Preliminary Public Input For Street Concepts

Prepared by HkGi – December 4, 2014

Queen Avenue Bike Boulevard Memorandum

Concept A: Includes bike lanes on both sides of Penn Avenue (removes on-street parking)

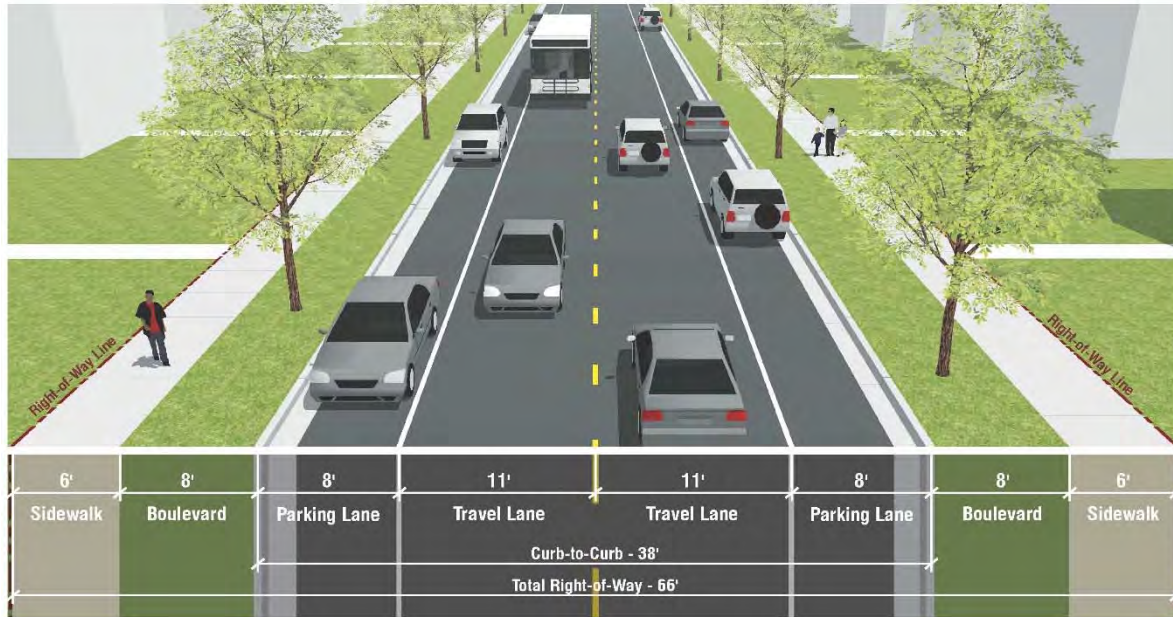
Roadway Concept A

- Prefer this concept with safe bike lanes
- Bike facilities must be maintained for safety
- Like bike lanes if there is a striped buffer

Concept B: Retains on-street parking on both sides of Penn Avenue

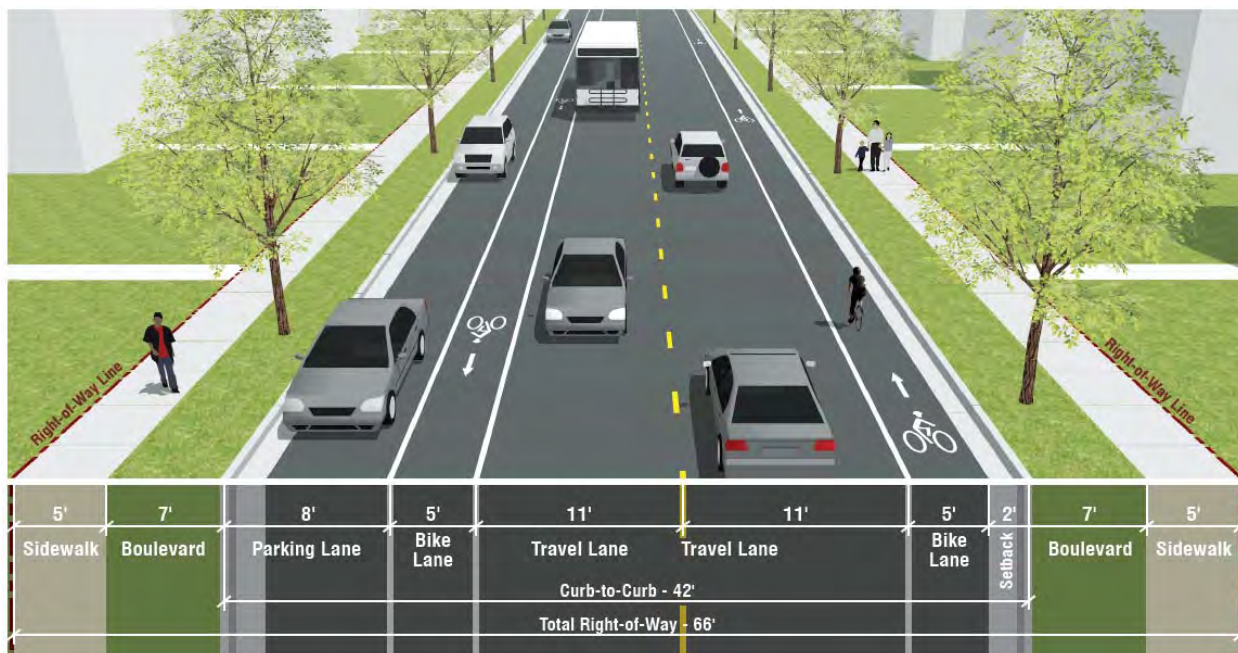
Roadway Concept B

- Need bike lanes for the next 75 years
- Need improved crosswalks
- Make it easier for bikes to be on Penn
- Less parking on busy street to help congestion and accidents
- Don't give up parking completely in residential areas
- Listen to people who live on Penn regarding parking
- I need more street parking, it is already difficult to find parking without restricting
- Prefer bikes off Penn
- Retain parking for businesses is high priority, also true for residents
- Removing parking will negatively impact businesses
- Parking should be concentrated at nodes

Concept C: Includes bike lanes on both sides of Penn Avenue and one side of on-street parking

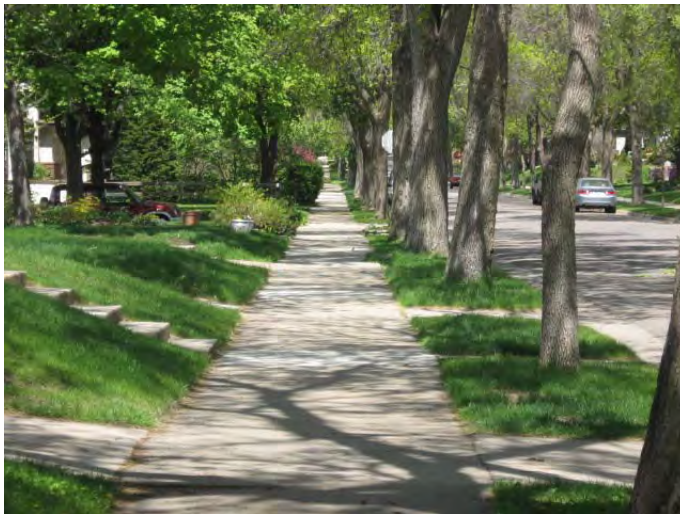
Roadway Concept C

- Must keep parking on one side

- Safety is important
- Look at N Damen Ave in Chicago
- Ensure access for EMS, fire, police vehicles
- We need traffic calming on Penn, narrow lanes slow traffic and reduce accidents (Minnehaha in St Paul 10-5-2007 and Como and Marshall in St Paul 11-5-2007)
- Adds safety to Penn and also includes parking
- Best solution for conflict, best of both worlds
- Needs to be on the online survey (2)
- Best solution to slow traffic on Penn Avenue down
- Good compromise between bikes and parking
- All concepts work, but we want to narrow curb width to gain more green
- Do bike lanes actually increase biking, has this been studied?
- Where does parking get moved to? Queen Ave is already maxed out
- Highest priority should be put on transit riders, pedestrians, greening, and lighting
- Nodes today are under-utilized, we need more development before more parking

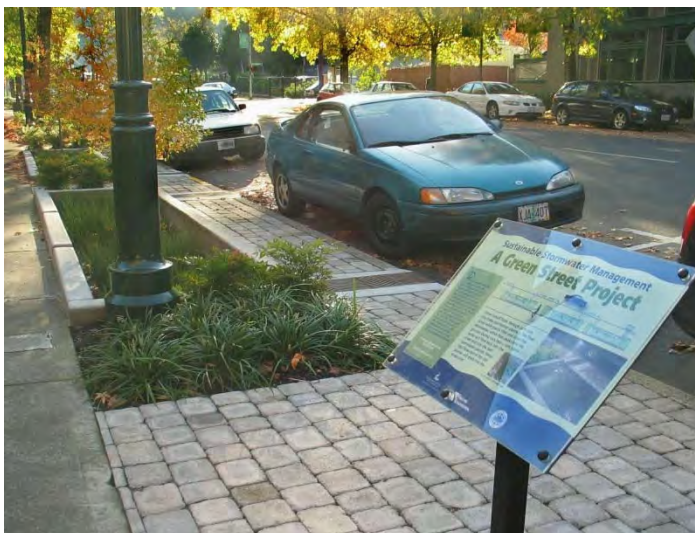
Community Input

- I want trees like the ones in this picture on Penn Avenue
- Worried that I will lose my front lawn
- I like an option that blends the standard and medium level elements

Community Input

- Any of these amenities are fine, just make them greener
- I like the garden in boulevard idea, just add vegetables

Community Input

- Don't like what is pictured in the high level amenities photo

- I like the signage/learning elements because we already have great and interesting things to highlight and share with others about in North Minneapolis
- We need more culture in these designs. We need to promote our history and culture

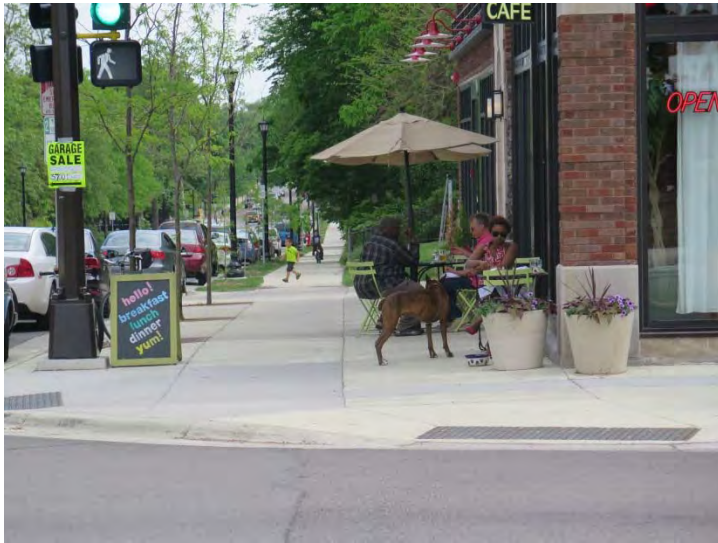
Community Input

- Power station to recharge cell phones
- Provide pay phones
- I like the standard option
- Appropriate without being too expensive
- Approachable working class feel with business opportunities for local entrepreneurs

Community Input

- Medium and high amenities are appropriate at the nodes
- More green
- Any of these options would be good
- Outdoor dining like this, with bike racks and neighborhood identity elements

Community Input

- Medium and high amenities are appropriate at the nodes

- Provide green space on roof tops in addition to amenities on the street
- High level amenities is appropriate but building heights should not exceed 3 stories
- I like the street trees, planters, trash, bike racks, special paving, ADA access, and bumpouts but this option also needs more mixed-use
- This option with signage and wayfinding
- I like the pavers and decorative trash cans
